Blue Print ADT39145, ADT39143, ADT39159, ADT39177

to fit:
Various models

TOYOTA VARIOUS MODELS - WATER PUMP MANUFACTURER

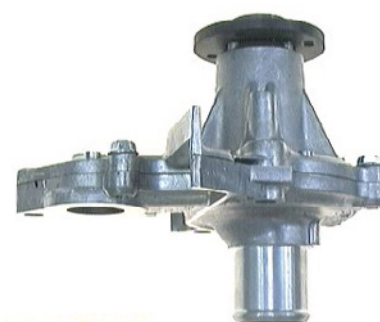
The original SEM type pump can be identified by the manufacturer's mark on the outer casing (see picture)

Side profile of the replacement SEM type pump with the front and rear casings pre-assembled.
